Memo To: Prospective Bidders
From: Dale M. Foster, PE, County Engineer *Dale*
Re: **Ocean Drive (CR619) Bridge over Corsons Inlet
Railing Improvements
Upper Township, Cape May County, NJ
ADDENDUM NO. 2**

ADDENDUM NO. 1

"CORSONS INLET BRIDGE RAILING IMPROVEMENTS"

Sketch 2

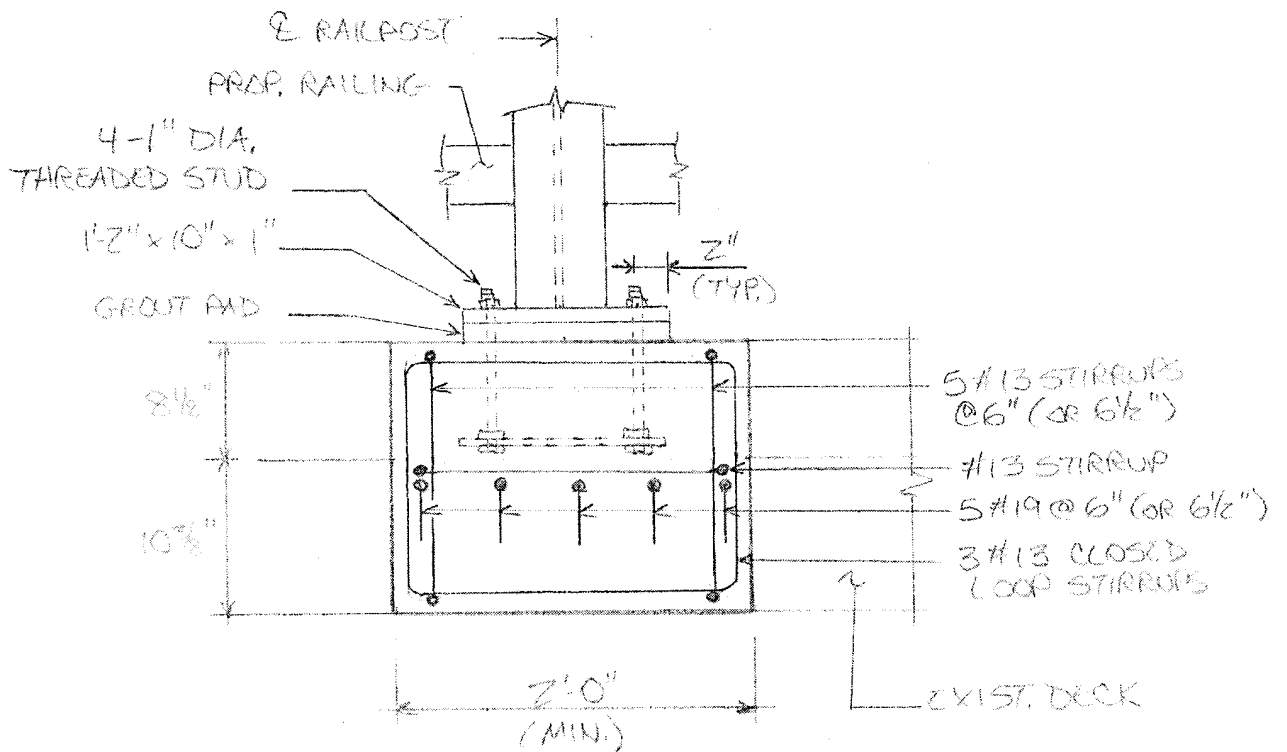
Sheet 17 – RAILING DETAILS - 1: Add the detail contained on the attached Sketch 2 to this sheet.
